# Hillston Feeder Reinforcement Review

Essential Energy

01211

5 June 2014

Figure 2: OZ-C-Splint published capacities with pole size and capacity ranges overlain.

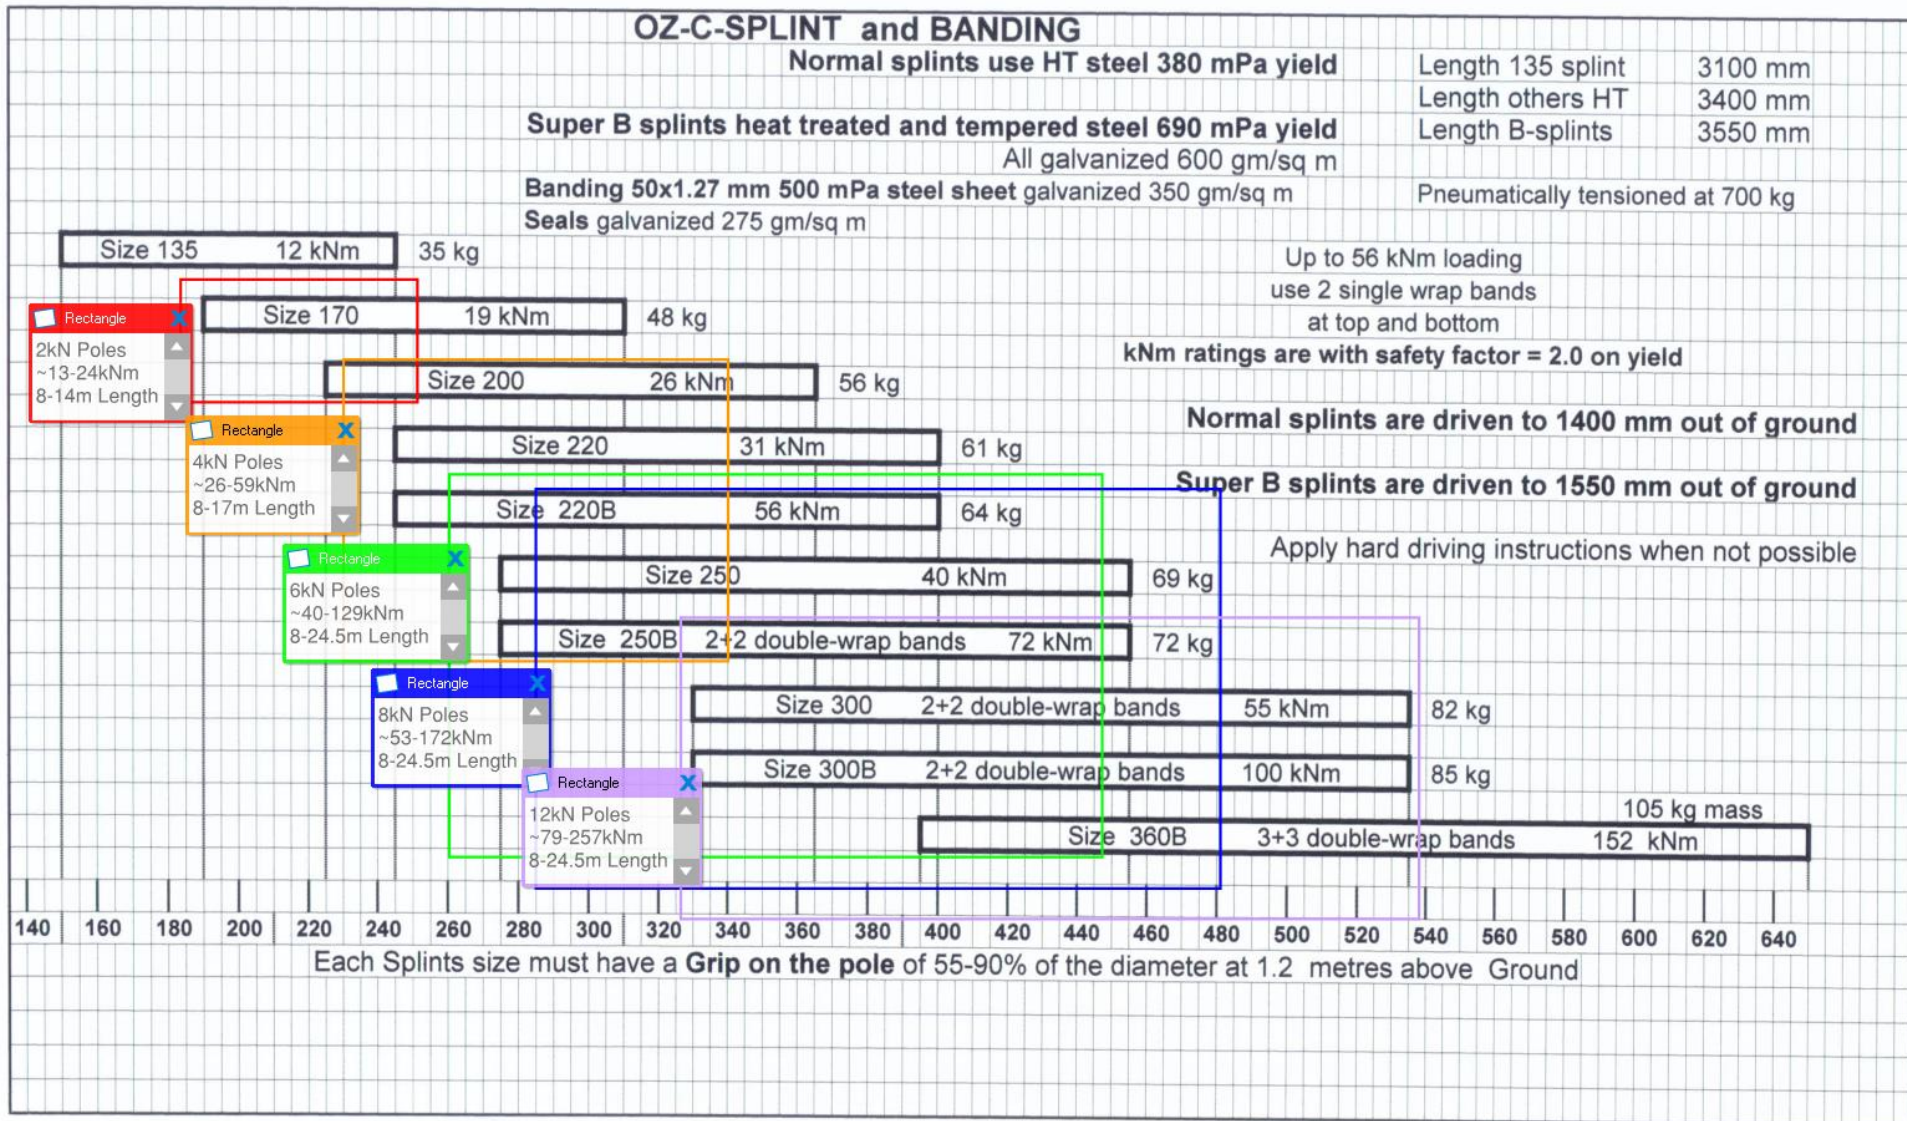
Figure 2 shows that there are some larger poles with high kN (kilonewton) ratings that may be unsuitable for single splint reinforcement. However, if two splints are used and it is assumed they share the load equally, then double splint systems should be able to support the majority of the working stress design loads that Essential Energy poles will be subjected to, assuming the actual capacity is as stated. Dual splints may require additional banding.

- There were a number of different documents provided that nominated material strengths, size ranges and bending moment capacities of the C-Splint nails. A minor concern stemming from this was that the reported steel yield strength for the normal splints ranges from 420 MPa for the older documents (circa 2001), to 380 MPa in the more recent (2006 on) documents. This is not a significant change, but Essential Energy need to ensure that their assumed capacities use the latest information.

- Based on calculations in accordance with AS 4100—1998, the capacities expressed by the supplier appear to correspond somewhat with the section capacity in the strong direction only, however this is not documented anywhere in the literature that we reviewed.

- The difference between section capacity (section yield) and member capacity (yield along the length of the member, usually due to lateral torsional buckling) is small for the larger poles, but based on the calculations shown in Appendix C, the member capacity can be as low as 62% of the section capacity for the 220B Splint, up to 92% for the 300 Splint. The higher steel strength “B” splints have a greater reduction than the normal splints, and the smaller sizes have a larger reduction than the larger sizes. In most cases with steel, calculations will prove conservative when compared to test results, however based on our experience with similar systems, testing is unlikely to show the C-Splints to have the supplier nominated capacities (with the FOS of 2).

Based on the findings, we have concerns that the C-Splints may be under-sized for the nominated capacities, particularly for the larger splints, and for splints that are not installed so that their strong axis is in line with the highest load direction.

Figure 3: Reinforcement orientation.

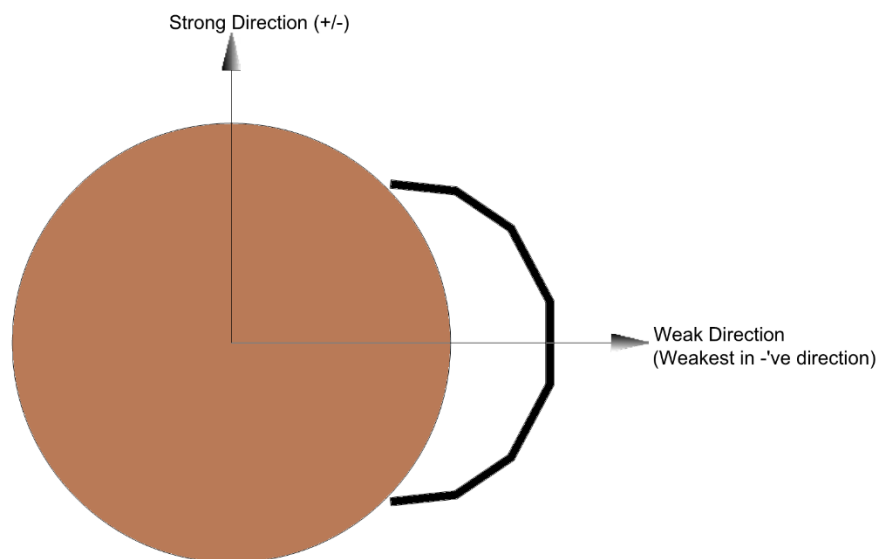
- 3 The literature provided appears to assume that the C-Splints are always installed so that the strong axis is always aligned with the axis of the critical load. However, there is no mention of this as being a requirement in any of the documentation we came across. This is a cause for significant concern if the installers are not aware of this requirement, because they are likely to install it in other orientations to avoid other attachments and clearance issues without knowing the effect this will have on the rated capacity. The weak axis capacities (the minimum rating for the two directions shown in Figure 3) are significantly below (approximately 33%–50%) the strong axis member capacities, which are already below the published capacities. This becomes critical, because a linear relationship between orientation and strength will give a 7% reduction in capacity with just a 10° misalignment with the load direction. A 30° misalignment will give a 22% strength reduction.

- 3 Due to the significant difference between the capacity of the reinforcement in the weak and strong directions, there is a risk that even if the reinforcement is sized appropriately for the load

in the strong-direction, any loads that occur in other directions may cause failure if they are large enough. Similar issues are seen in New Zealand where in-line loads from snow or even failure of an adjacent pole have led to over-stressing of the rectangular concrete poles, which has led to failure about the weak axis. This would be more of an issue for un-stayed terminations and angle poles within Essential Energy's network. If there are numerous reinforced poles adjacent to each other, the risk of cascade failure is also heightened.

Figure 5: Residual factor of safety for a range of original diameter and wall thickness combinations. Red box outlines the ground line dimensions of poles that can be reinforced (does not consider capacity requirements).

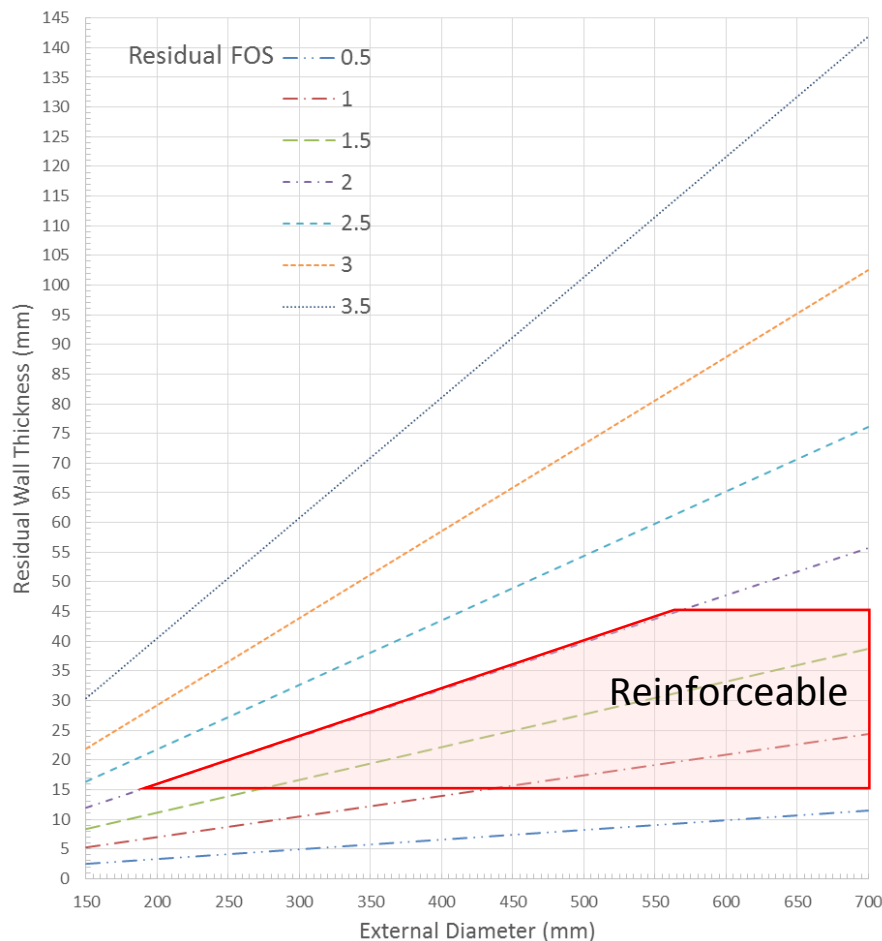
Figure 5 shows a representation of the relationship between external diameter, wall thickness, and residual FOS for the pole (based on a FOS = 4 for the new pole). Using the Essential Energy reinforcement and replacement inspection criteria, the shaded red box outlines the situations in which a pole may be reinforceable. Note that using a wall thickness for replacement of 30mm will not see the FOS for the pole drop below 2 for poles less than 370mm diameter. If the pole isn't fully utilised strength-wise when new, this will be even worse. This explains why Essential Energy poles are rarely earmarked for reinforcement and are replaced instead.

Essential Energy criteria is based on both residual FOS and wall thickness, but the two types of criteria do not appear to interact to allow many poles to be reinforced, i.e. the minimum wall thickness may be reached before the FOS for reinforcement is reached and the pole is replaced rather than reinforced.

Hence, Essential Energy may want to consider aligning the capacity triggers differently. Possible limits that would currently not produce an insurmountable number of poles to be reinforced might be to have poles earmarked for reinforcement once they reach a FOS of 3, whilst keeping the wall thickness triggers the same or increasing slightly to 20-25mm, with an above ground wall thickness minimum of 10-15mm for replacement of a reinforced pole. This would remove some of the confusion that arises between the criteria for unreinforced and reinforced poles. Ultimately, Essential Energy will set the limits so as to maximise asset reliability and minimise expense, but there needs to be better definition between reinforcement and replacement criteria if Essential Energy are to increase the number of pole reinforcements.
